ADDENDUM NUMBER: One (1)

PROJECT: Montgomery County Courts Center – Generator Replacement

ENGINEER: Erich Vierkant, PE
IC Thomasson Associates, INC

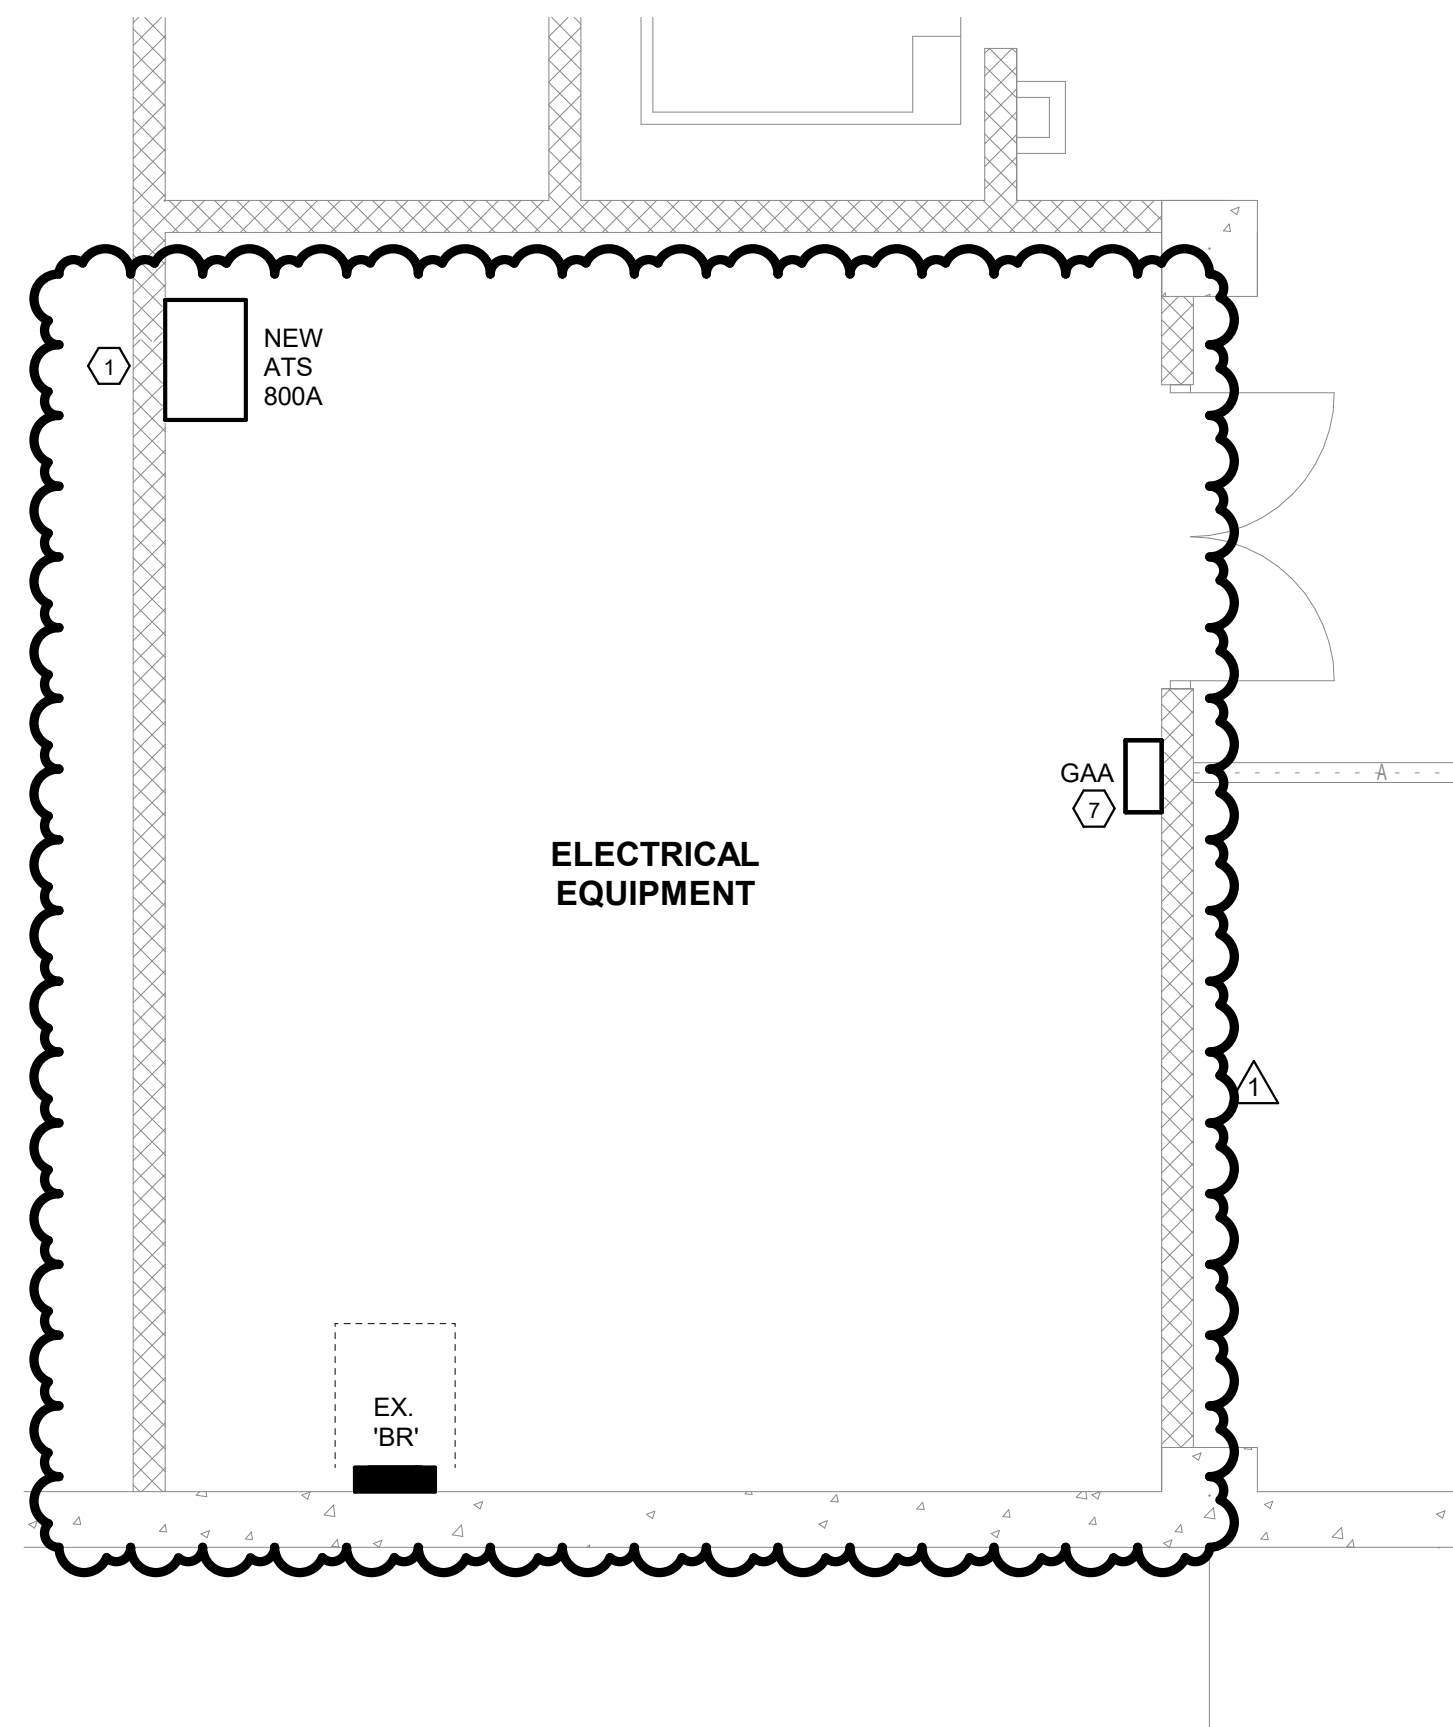
QUESTION: What is the required generator mounted output breaker ampere rating and is the 800A ECB shown intended to limit the generator output?

QUESTION: Is the new 800A ATS to be 3-pole or 4-pole switched neutral.

QUESTION: Will the 225A Historic Courthouse ATS be 3-pole or 4-pole.

ICT ANSWER: Please see attached riser diagram for all 3 output breakers. Output is not limited.

ICT ANSWER: ATS shall be 3 pole per revised drawing attached. No ground-fault equipment is associated with the project.

ICT ANSWER: ATS shall be 3-pole per revised drawing attached. No ground-fault equipment is associated with the project.

ELECTRICAL PLANS			
MONTGOMERY COUNTY COURTHOUSE			
NASHVILLE		TENNESSEE	
		I.C. Thomasson Associates, Inc. A Salas O'Brien Company NASHVILLE, TN. (615) 346-3400	
DRAWN BY	Author	JOB No.	2645-00562-00
CHECKED BY	Checker	ISSUE DATE	06/19/2026
FILENAME		PLOT DATE	
			SHEET No. E101

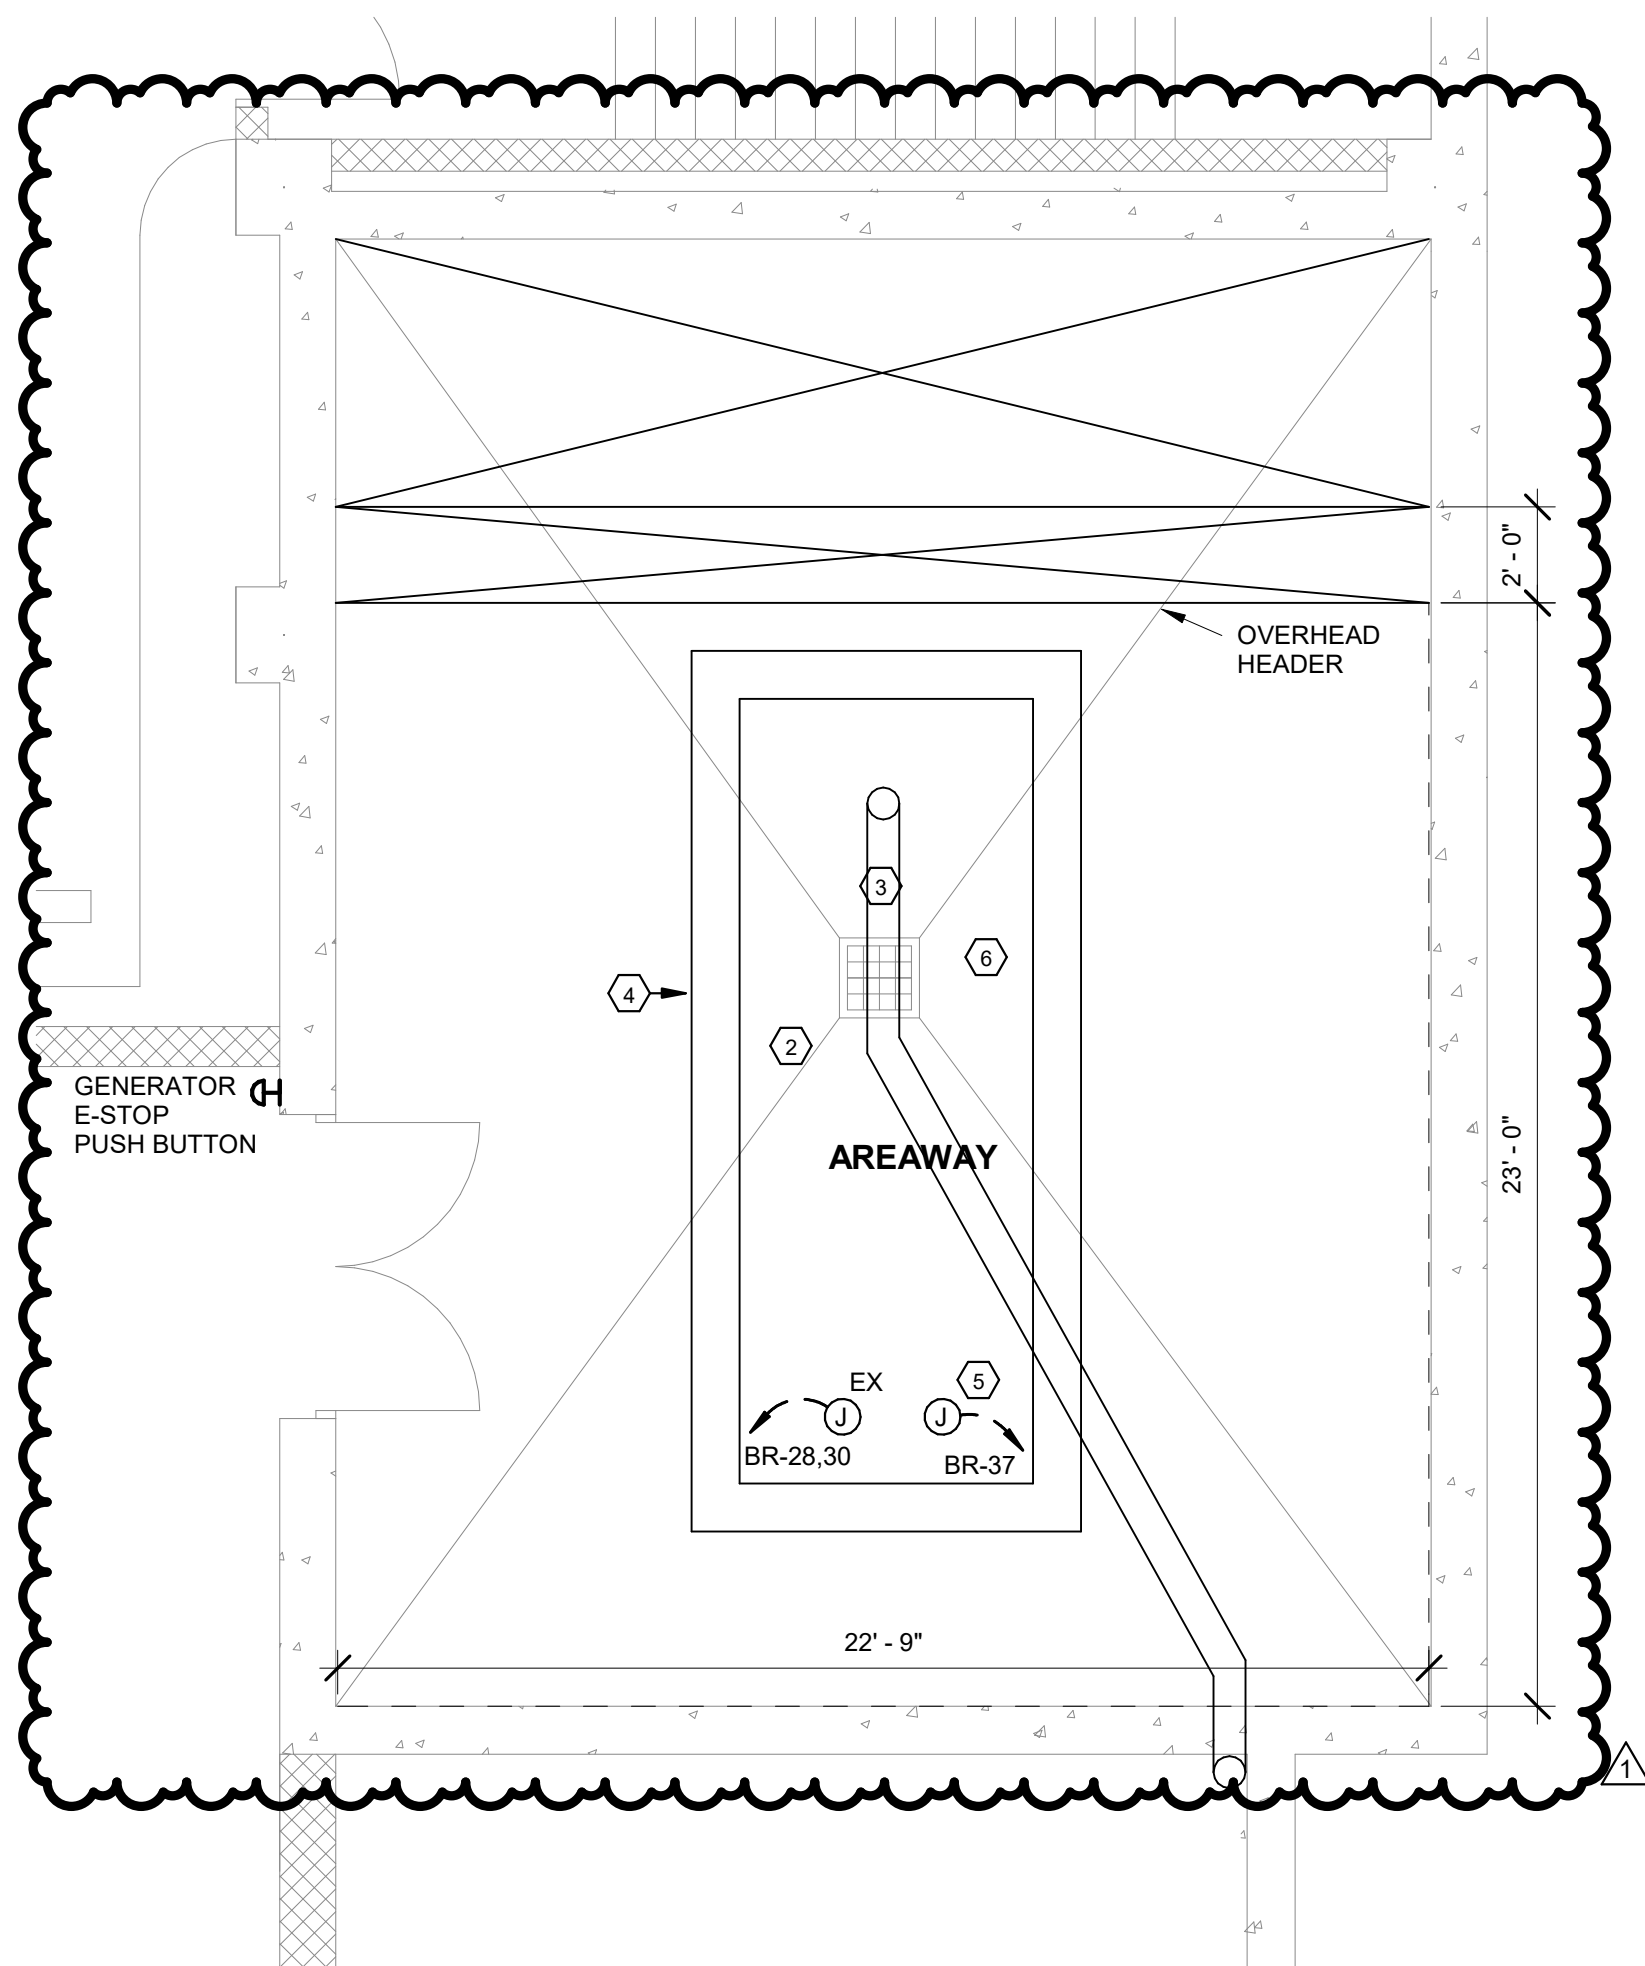
QUESTION: What are the requirements for the existing concrete generator pad?

QUESTION: Please identify the required location for the NFPA 110 remote generator annunciator as required in the specification.

QUESTION: What is the required location of the remote generator emergency stop specified in Section 26 32 13?

ICT ANSWER: Generator pad is to remain and be modified. Detailed description is provided in revised sheet E101, attached to this addendum.

ICT ANSWER: Reference revised drawing E101 (attached). Remote annunciator shall be wall mounted in Courts Center basement electrical room.

ICT ANSWER: Generator E stop shall be located inside the mechanical room door as you enter from the generator enclosure (See revised drawing E101).

- CONTRACTOR SHALL EXTEND EXISTING HOUSE KEEPING PAD TO EXTEND 12" MINIMUM BEYOND NEW GENERATOR. UTILIZE 12" DOWELS DRILLED 6" INTO EXISTING PAD ON 12" CENTERS. UTILIZE WELDED WIRE MESH FOR NEW PAD. GENERATOR SHALL BE SECURED WITH 8" MINIMUM THREADED BOLT ANCHOR, SIMPSON TITEN OR EQUAL BY HILTI. NO WEDGE ANCHORS WILL BE ACCEPTED.

- PROVIDE GENERATOR ANNUNCIATOR ON WALL IN ELECTRICAL ROOM WHERE SPACE IS AVAILABLE.
